United States Department of the Interior
FISH AND WILDLIFE SERVICE
Stockton Fish and Wildlife Office
4001 North Wilson Way, Stockton, CA 95205-2486
209-946-6400 (Voice) 209-946-6355 (Fax)

July 17, 2003

Subject: Informal Consultation with regards to Steelhead for Phase II Gravel Introduction at La Grange on the Tuolumne River, CA.

Figure 4. Gravel introduction site 18b, La Grange

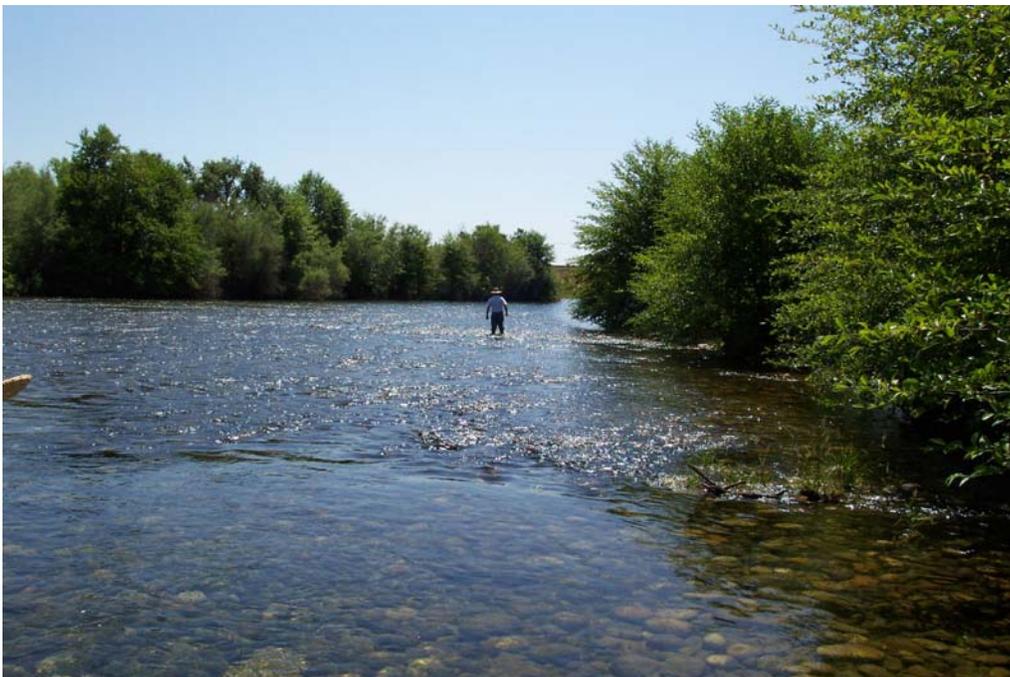
Site 18b appeared to have good gravel on the slightly large side for spawning purposes for both Chinook and steelhead/trout (Figure 4). Top dressing may be beneficial in the future. There were some good pools just downstream of this gravel introduction site on the north side that should be preserved (Figure 5). The group recommended filling the south side of the channel upstream of the bridge to keep the thalweg on the north bank.
